SUBJECT: Contract No. 8496
NSC – BNSF Railway Structures/Realignment
FA Project No: Tiger4-0395(100)

**CHANGE ORDER TRANSMITTAL
CHANGE ORDER NO 14**

This change order compensates the Contractor for revisions made to Retaining Wall 6 in order to meet BNSF and AREMA requirements.

CONTRACT NO: 008496 FEDERAL AID NO: TIGER4-0395(100)
CONTRACT TITLE: US 395, NSC - BNSF RAILWAY STRUCTURES/REALIGNMENT
CHANGE ORDER NO: 14 BNSF RTW6 REVISION

RTW6 WALL
DETAILS 3 OF 3

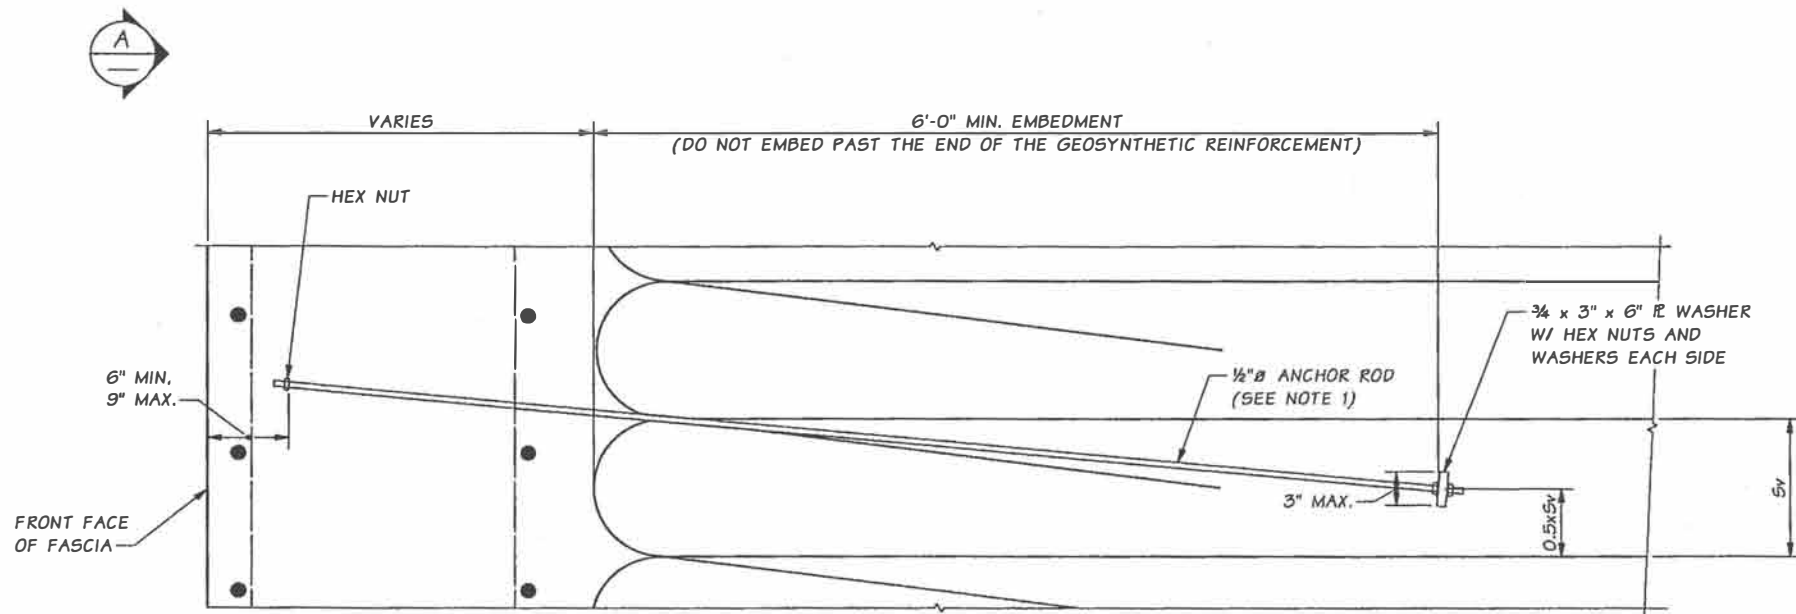
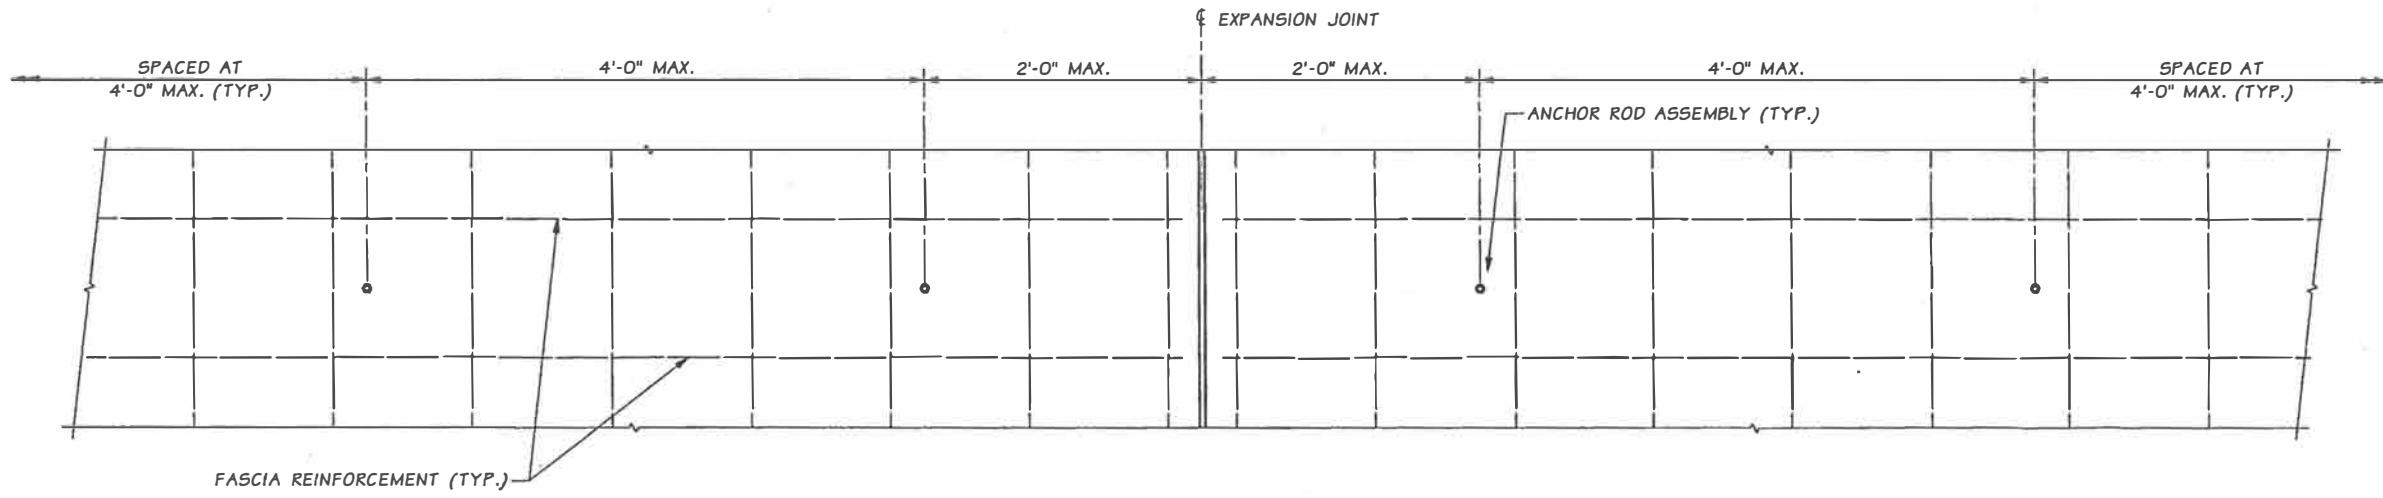
4. ANCHOR ROD ASSEMBLY MAY BE MODIFIED AS FOLLOWS TO FACILITATE FORMING OF THE FASCIA:
 - A) LENGTH AND THICKNESS OF R WASHER EMBEDDED IN THE GEOSYNTHETIC WALL MAY BE INCREASED AS NECESSARY TO RESIST THE FORM LOADS.

- B) SPACING OF ANCHOR ROD ASSEMBLIES MAY BE REDUCED AND NUMBER OF ANCHOR ROD ASSEMBLIES MAY BE INCREASED TO FACILITATE FORM TIE LOCATIONS.
 - C) HEX NUT NEAREST THE FRONT FACE OF THE FASCIA MAY BE CHANGED TO A COUPLER TO FACILITATE REMOVAL OF FORM TIES AFTER CONCRETE IS CAST. THE COUPLER SHALL CONFORM TO THE SAME STANDARDS AS THAT SPECIFIED FOR THE NUT AND SHALL BE GALVANIZED IN ACCORDANCE WITH ASTM F2329.

- D) THE CONTRACTOR SHALL SUBMIT WORKING DRAWINGS AND CALCULATIONS IN ACCORDANCE WITH STANDARD SPECIFICATION 6-01.9 FOR ANY MODIFICATIONS TO THE ANCHOR ROD ASSEMBLY DETAIL.
